PCI IDE Application Note

National Semiconductor
Application Note 963
Lakhdar Iguelmamen
Hans Wang
September 1994

ERRATA

State Machine: Bubble Diagrams for PCI_GAL.OPL

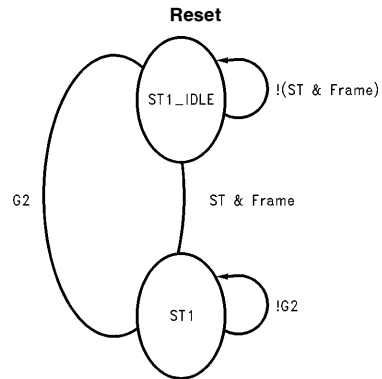
```
begin header
end header
begin definitions
device gal 16v8;
input clk=1, frame=2, idsel=3, cbe0=4, cbe1=5, reset=6, cbe2=7, cbe3=8, ad7=9,
AD6=15, AD5=16, AD4=17;
output (com) idsel_out=12;
feedback st=13, st1=14;
end definitions
{
CLK FRAME IDSEL CBE0 CBE1 RESET
ST ST1 IDSEL_OUT
}
```

```
g1 = !frame * idsel * cbe3 * !cbe2 * cbe1 * !cbe0 * ad7;
st := reset * ( st * !g1 + !st * g1 );
{st.re = reset;}
st.c = clk;
g2 = frame * !st;
st1 := reset * ( st1 * !g2 + !st1 * st * frame );
{st1.re = reset;}
st1.c = clk;
idsel_out = idsel * (st1 + ad7 + ad6 + ad5 + !ad4);
End Equations
```

PCI-IDE Controller with Patch Logic

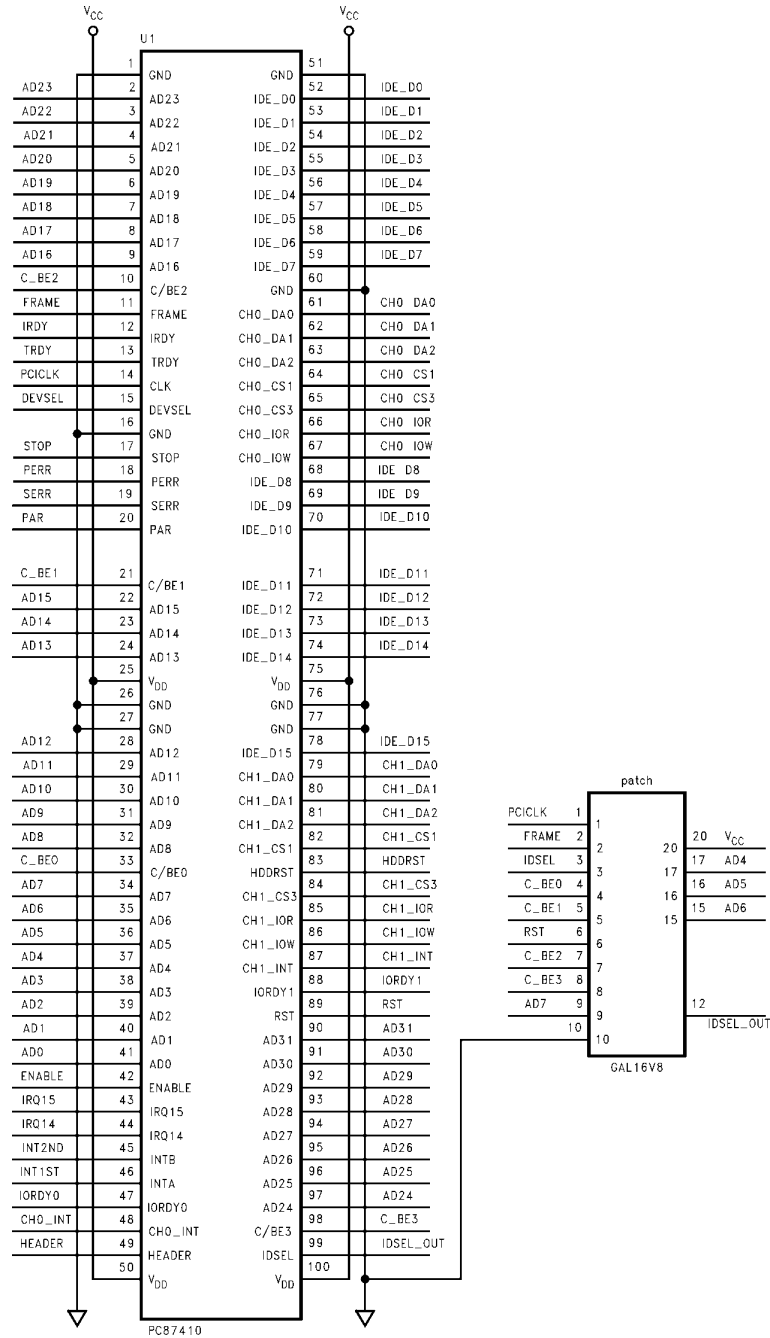
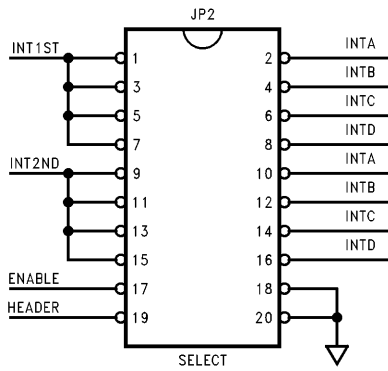
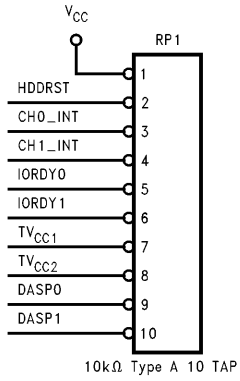
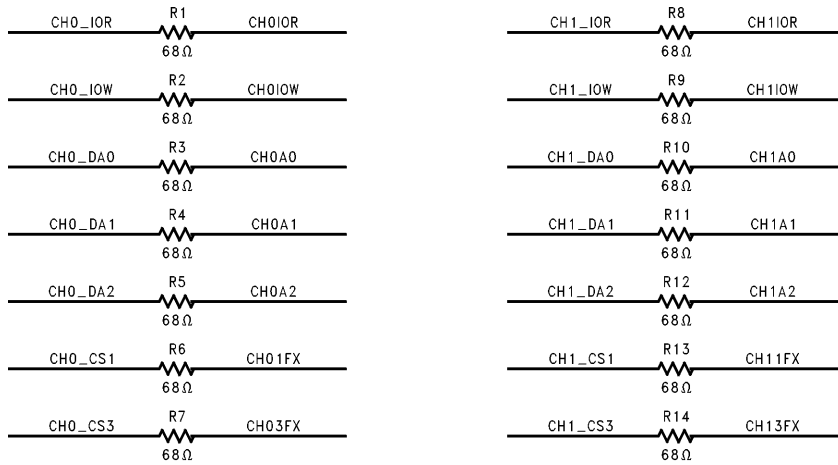
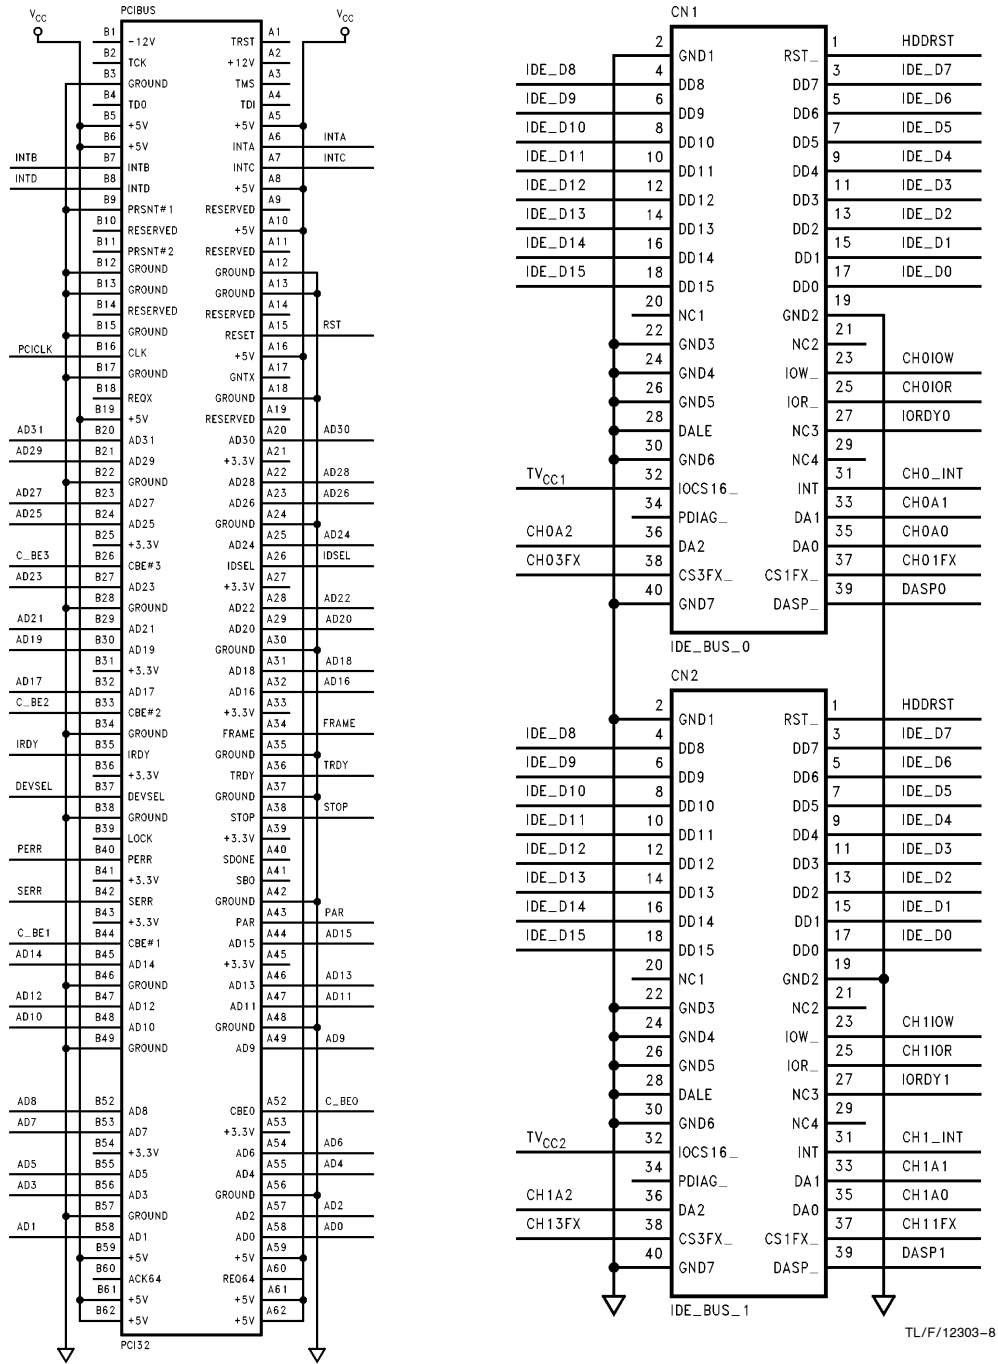
The hardware patch solution is designed to fix the problem of existing demo boards' incompatibility with existing BIOS. This solution uses a GAL to fix the problem and works with existing BIOS without any power-on procedures. But it requires software changes to run on/off the hardware patch.

This document describes how to modify the existing demo board and what software drivers changes are required to turn on/off the software patch.

- Requires a PAL
- No BIOS change required
- Wire the following signals to the GAL socket

Pin #	Connect
1	PCI CLK
2	FRAME #
3	IDSEL (from the PCI local bus)
4	C_BE0 #
5	C_BE1 #
6	RST #
7	C_BE2 #
8	C_BE3 #
9	AD7
10	GND
11, 20	VCC
12	IDSEL_OUT (pin-99 or PC87410 "IDSEL")
15	AD6
16	AD5
17	AD4

For more details, please refer to the schematic of PCI-IDE controller with patch logic.

The following is the patch logic for PC87410 PCI-IDE controller with National's OPAL format. The PAL device could be either G16V8 or P16R4. See attached schematics with Patch Logic.
